SUBJECT: ISSUANCE OF AMENDMENT NO. 87 TO FACILITY OPERATING LICENSE
NO. NPF-21 - WPPSS NUCLEAR PROJECT NO. 2 (TAC NO. 71941)

WASHINGTON PUBLIC POWER SUPPLY SYSTEM
DOCKET NO. 50-397
NUCLEAR PROJECT NO. 2
AMENDMENT TO FACILITY OPERATING LICENSE

Amendment No. 87
License No. NPF-21

SAFETY EVALUATION BY THE OFFICE OF NUCLEAR REACTOR REGULATION
SUPPORTING AMENDMENT NO. 87 TO FACILITY OPERATING LICENSE NO. NPF-21
WASHINGTON PUBLIC POWER SUPPLY SYSTEM
NUCLEAR PROJECT NO. 2
DOCKET NO. 50-397

FIGURE 3.4.6.1
 MINIMUM REACTOR VESSEL METAL TEMPERATURE VERSUS
 REACTOR VESSEL PRESSURE

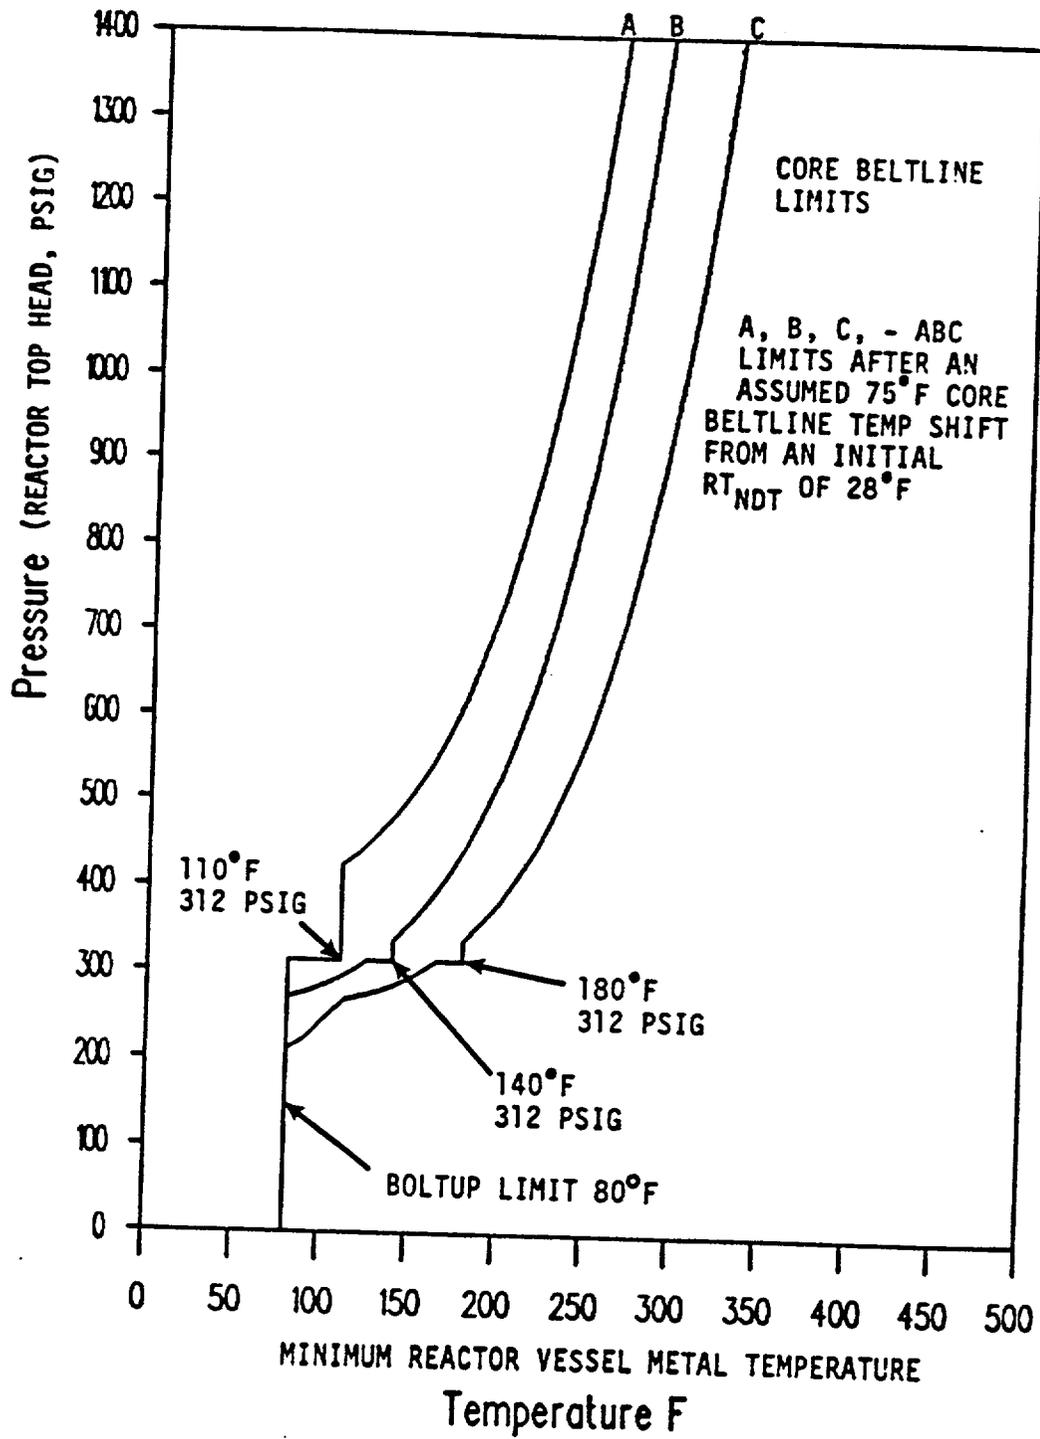
This amendment revises Technical Specification 3/4.4.6, Reactor Coolant System Pressure/Temperature Limits by revising the curves which set forth the pressure/temperature limit lines. Specifically Figure 3.4.6.1 will be inserted in the technical specifications. Existing Figure 3.4.6.1-1 and Figure 3.4.6.1-2 will be removed. Existing Figure 3.4.6.1-1 had set limits applicable during the early life of the plant and was no longer applicable. References to the two figures in the index, in specification 3/4.4.6 and in the bases section 3/4.4.6 have been revised to refer to the single new figure. The bases have also been revised to reflect that nickel rather than phosphorous is the metal reported with reactor vessel toughness test results.

The April 5, 1990, letter proposed a further revision to Figure 3.4.6-1 of the Technical Specifications. This proposed revision made the limits more conservative by accounting for through-wall temperature corrections. This change is similar to the changes made in the October 27, 1989, submittal and does not alter the staff's initial no significant hazards consideration.

3.4.6.1 The reactor coolant system temperature and pressure shall be limited in accordance with the limit lines shown on Figure 3.4.6.1 (1) curve A for hydrostatic or leak testing; (2) curve B for heatup by non-nuclear means, cooldown following a nuclear shutdown and low power PHYSICS TESTS; and (3) curve C for operations with a critical core other than low power PHYSICS TESTS, with:

For the limiting beltline material, plate C1272-1, the staff calculated the ART to be 103.2°F at 1/4T (T = reactor vessel beltline thickness) and 89°F at 3/4T at 32 EFPY. The staff used a neutron fluence of 8E17 n/cm² at 1/4T and 3.6E17 n/cm² at 3/4T. The ART was determined by Section 1 of RG 1.99, Rev. 2, because no surveillance capsules were removed from the WNP-2 reactor vessel.

The licensee used the method in RG 1.99, Rev. 2, to calculate an ART of 103°F at 1/4T for the same limiting plate metal. The staff judges that a difference of 0.2°F between the licensee's ART of 103°F and the staff's ART of 103.2°F is acceptable. Substituting the ART of 103.2°F into equations in SRP 5.3.2, the staff verified that the proposed P/T limits for heatup, cooldown, and hydrotest meet the beltline material requirements in Appendix G of 10 CFR Part 50.
